**FINAL REPORT**

Piping Design Review  
for  
Perry Nuclear Power Plant - Unit 1

Cleveland Electric Illuminating Company  
Perry Nuclear Power Plant  
10 Center Road  
Perry, Ohio 44081

February 27, 1984

FIGURE 1

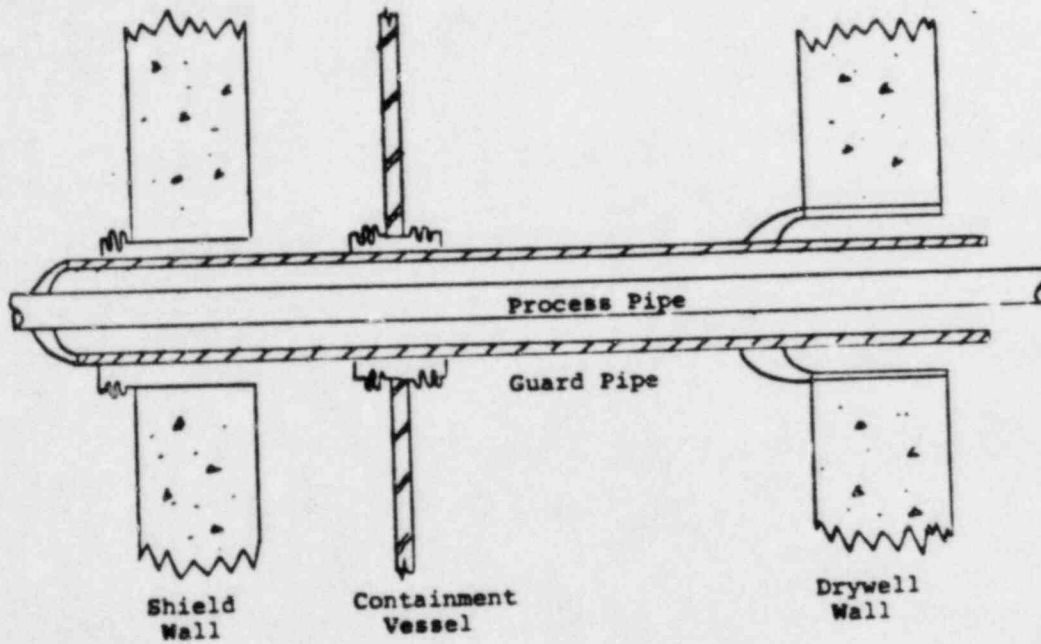
\*The actual moment arm shown on the vendor drawing is 14.90 in.
